THE ILLINOIS STATE TOLL HIGHWAY AUTHORITY

CONSTRUCTION BULLETIN No. 16-01

SUBJECT: Median Mounted Light Pole Foundations & Light Pole Mounting

ANCHOR BOLT DETAIL

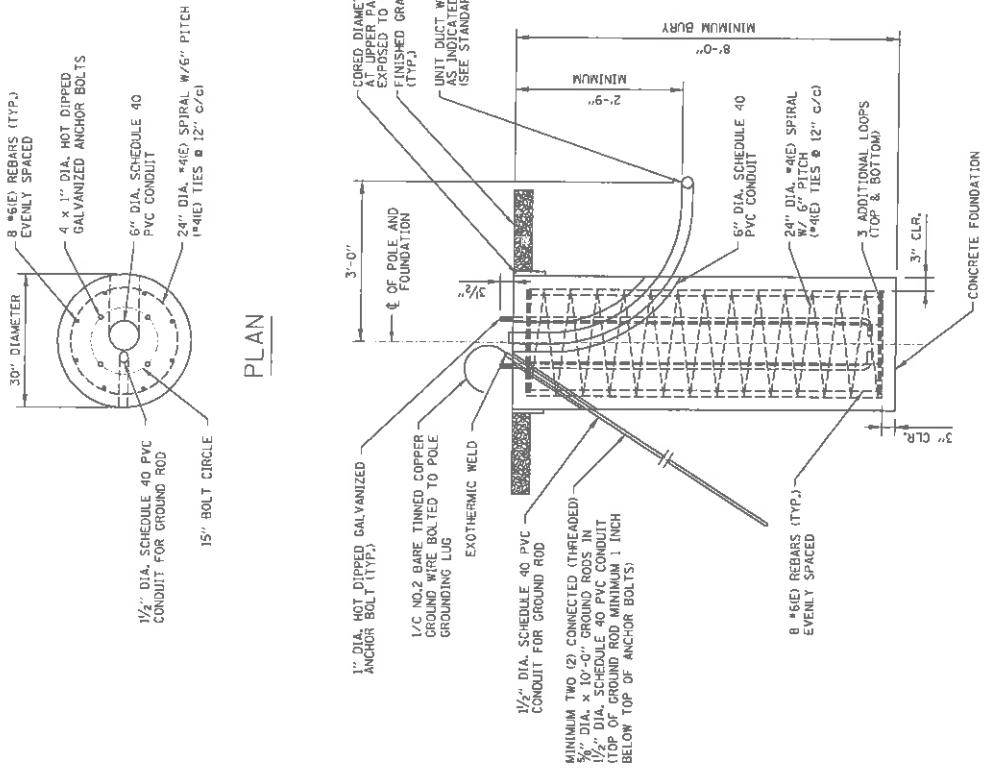
- Illinois Tollway Standard Drawing H1-05 (LIGHT STANDARD FOUNDATION) has been revised as follows:
 - Increase of anchor bolt projection from the top surface of median barrier light standard foundation from 3.5-inches to 6-inches.

- Increase to threaded portion of anchor bolts from 6-inches to 12-inches.
- Illinois Tollway Standard Drawing H2-04 (LIGHT STANDARD DETAILS) has been revised as follows:

LIGHT STANDARD - SINGLE MAST ARM

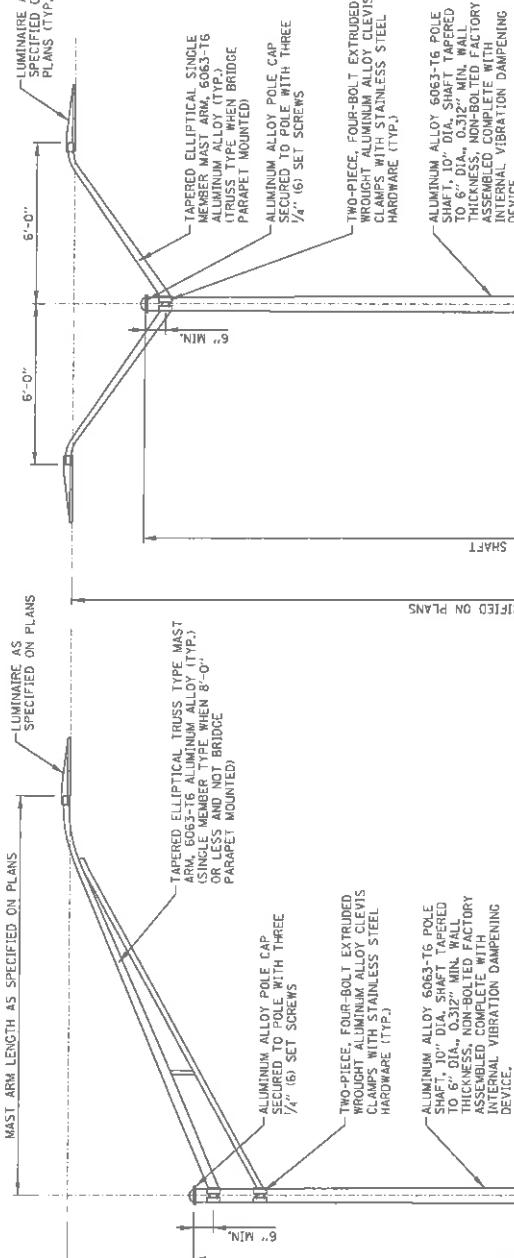
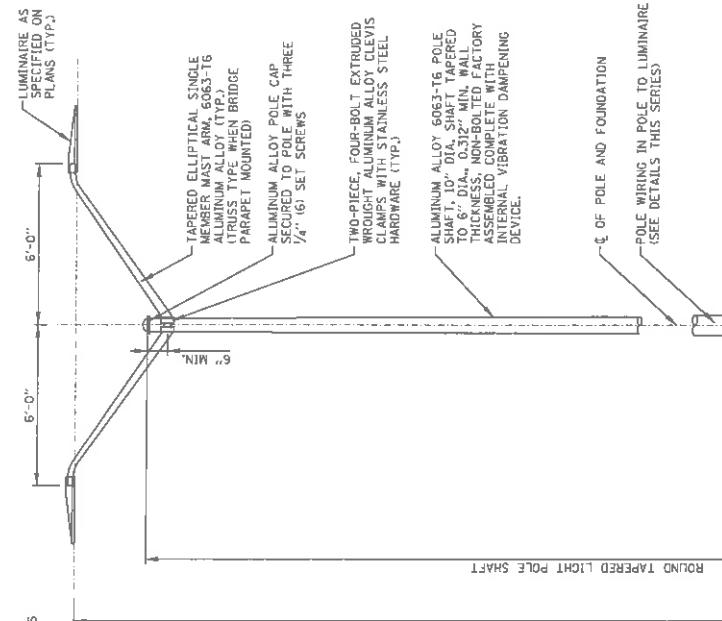
- Removal of 45'-0" light pole shaft dimension.
 - Removal of mast arm dimensions for twin mast arm light standards and added guidance regarding the usage of truss type mast arms.
